**Monks Orchard Residents' Association  
Planning**

3<sup>rd</sup> April 2020

<b>Reference</b>	<b>20/01256/FUL</b>
<b>Application Received</b>	<b>Mon 16 Mar 2020</b>
<b>Application Validated</b>	<b>Mon 16 Mar 2020</b>
<b>Address</b>	<b>Land R/O 211 Wickham Road Croydon CR0 8TG</b>
<b>Proposal</b>	<b>Demolition of existing structures to the rear of 211 Wickham Road and erection of a two storey building containing four dwellings with associated alterations</b>
<b>Case Officer</b>	<b>George Clarke</b>
<b>Consultation Expiry Date</b>	<b>Wed 15 Apr 2020</b>

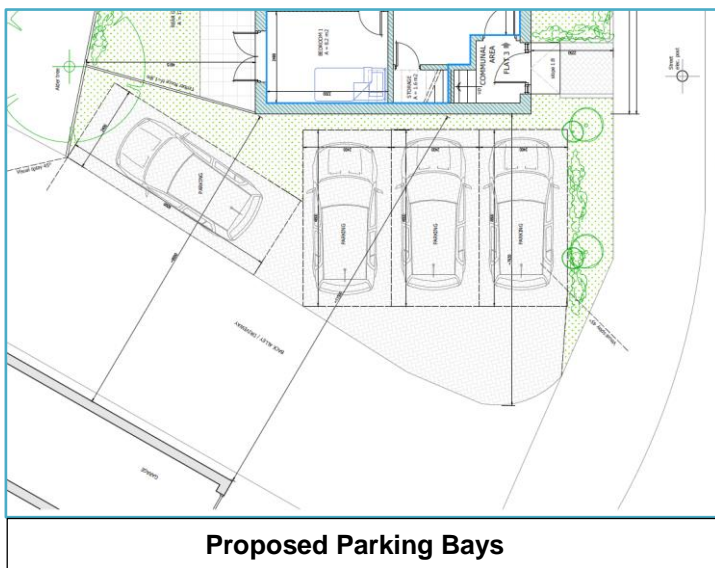
**Comment #1      Flats 2 & 4 have NO private open space as required by:**

The Policy States **“ALL PROPOSALS FOR NEW RESIDENTIAL DEVELOPMENTS”** shall have private amenity space as defined by the Policy DM10.4 c).

The proposal would therefore be required to meet these **“exceptional circumstances”** defined in paragraph 6.76 in order to meet the policy and evaluation suggests this would meet the required modified GIA for Flats 2 & 4. Flat 2 & 4 have proposed GIA of 44.2m<sup>2</sup> and for 1b1p accommodation would require 5m<sup>2</sup> Private Amenity Space which when added to the Table 3.1 Requirement of 39m<sup>2</sup> equates to 44m<sup>2</sup> which is 0.2m<sup>2</sup> within the specified requirement.

However, does the Case Officer consider that this proposal has the appropriate **“Exceptional Circumstances”** of **“Site Constraints”** criterion which can allow and provide for para 6.76 to be considered necessary or could the **5m<sup>2</sup> Private Amenity Space** be provided by judicious rearrangement of the internal accommodation to allow provision of Private Outside Amenity balconies for Flats 2 and 4, either at front or rear elevations? **Please define the Exceptional Circumstances.**

Figure 2.29e: Requirements for entrances and boundary treatments.

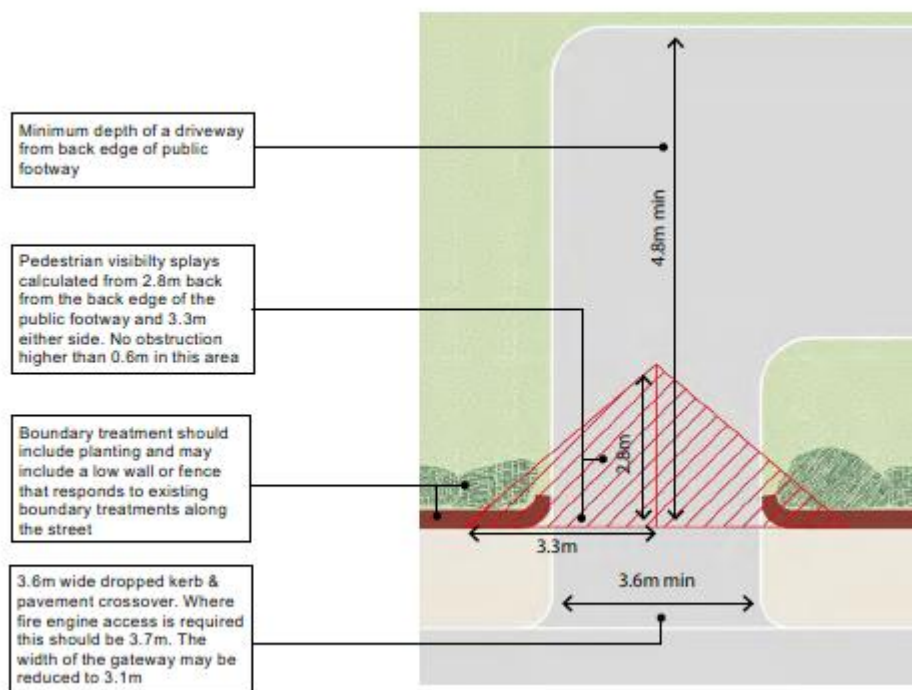
**Comment #3 SPD2 Chapter 2 Suburban Residential Developments Section 2.29.4**

“Entrances should avoid tall wall or wooden fences either side of a new driveway that close off the development to the street.”

**SPD2 Policy 2.29 e) states: For “Pedestrian Visibility Splays from 2.8m back from the back edge of the public footway and 3.3m either side. There shall be no obstruction higher the 0.6m”.**

**Access Driveway at boundary of #2 Ridgemount Avenue Showing the 1.8m Tall Fencing up to the boundary of the Public footpath, precluding any visibility splays to the North as viewed from the Exit from the New Parking Bays into Ridgemount Avenue.**

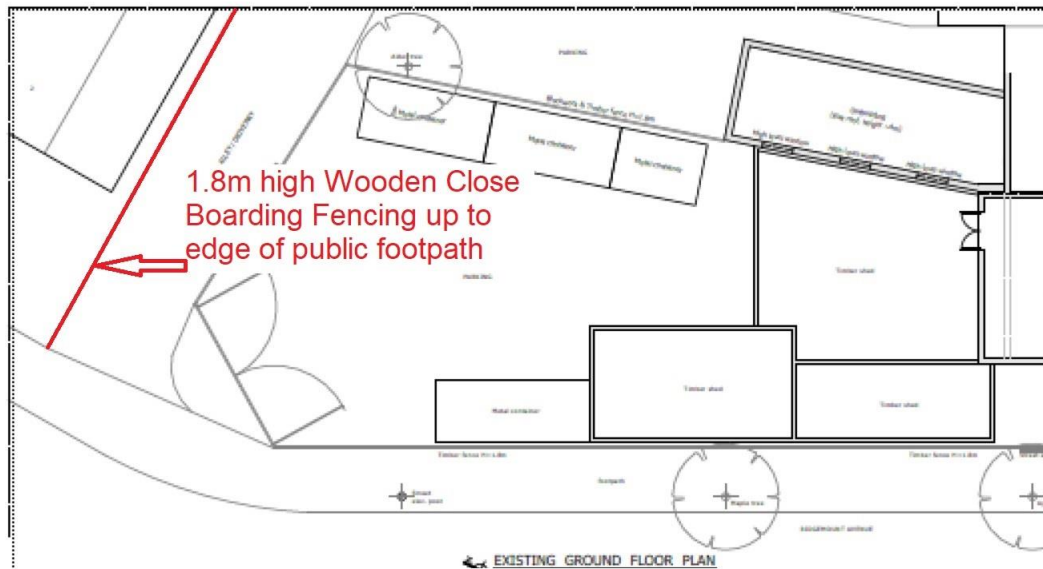
It is noted that the **1.8m Close Boarded fencing** on the side boundary of **2 Ridgemoor Avenue** precludes any visibility splay of the footpath to the north when exiting the new access driveway for the proposed car parking bays into **Ridgemoor Avenue**.
